Technical Service Information

NISSAN RL4F02A LOCK-UP SHUDDER

APPLIED MODELS: 1985-1987 Maxima SERVICE INFORMATION

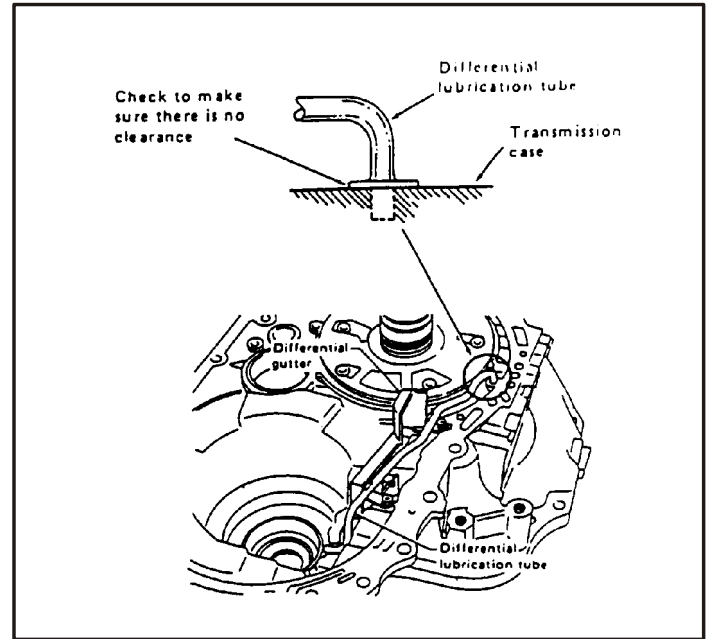
2. Differential lubrication tube. The tube should have an interference fit into the transmission case. If the tube is loose or broken, replace it with a new tube, (part number 31328-21X03).

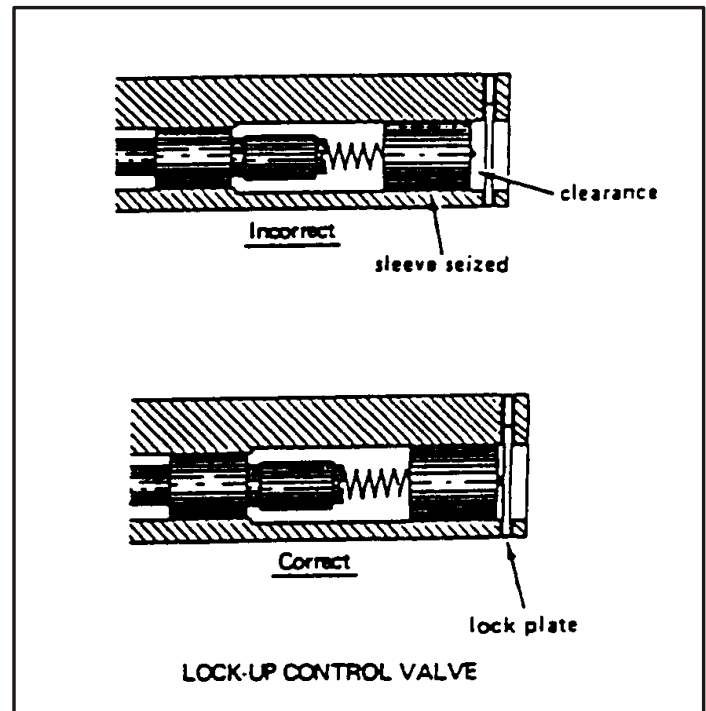
3. Check to make sure the lock up control sleeve is not seized in the control valve body. Also, check to make sure no other valves are seized in the valve body. Clean, lubricate and check all components in the control valve body as necessary.

4. Replace the 2-3 shift valve and the 4th speed cut spring with new parts. (See chart on page 3/4.)
